**Re: Initial Submission Review – Fitzsimons Innovation Community Subdivision Flg No 3 - Final Plat**  
Application Number: **DA-1233-45**  
Case Numbers: **2020-3024-00**

# Initial Submission Review

D. CONCEPTUAL E. 23RD AND RACINE STREET INTERSECTION WITH TURN LANE ::  
 Typical two lane street with turn lane at intersection / Bicycle lanes  
 If turn lanes are not necessary, curb extensions should be used to decrease crossing distances.  
 \*see notes 1, 2, and 3 on this sheet.

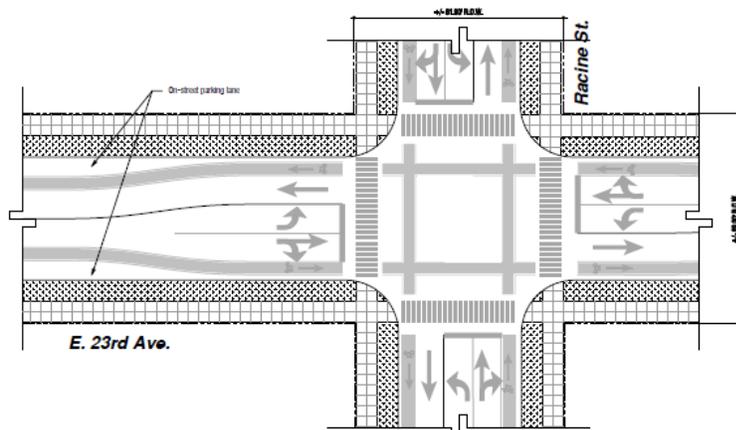
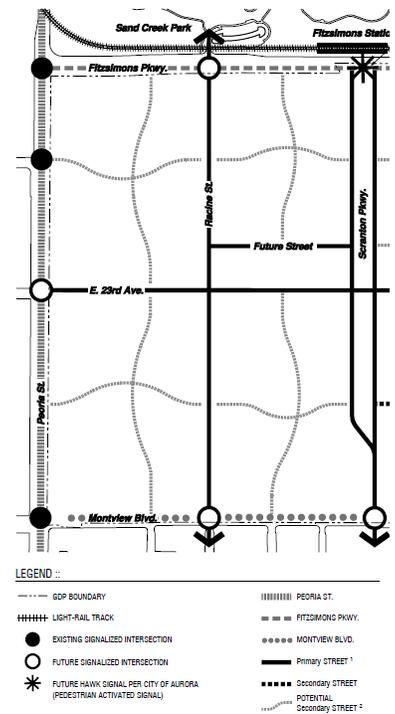
- 2A. Additional discussion is necessary regarding the request for a roundabout. I suggest continued collaboration on this issue.
- 2B. Planning does not support the construction of a roundabout at this location as it does not comply with the Fitzsimons Innovation Community GDP.

- 2D. The E 23<sup>rd</sup> Avenue and N Racine Street intersection is illustrated in the GDP as a typical two-lane street with turn lane at the intersection. While it is a conceptual illustration, the shift to a roundabout does not comply with the GDP, which was reviewed and approved by Public Works with Fitzsimons GDP Amendment No. 6.

- 2E. A GDP design standard requires buildings to front the street. A roundabout causes buildings to be shifted back and the design standard will not be met as a result.
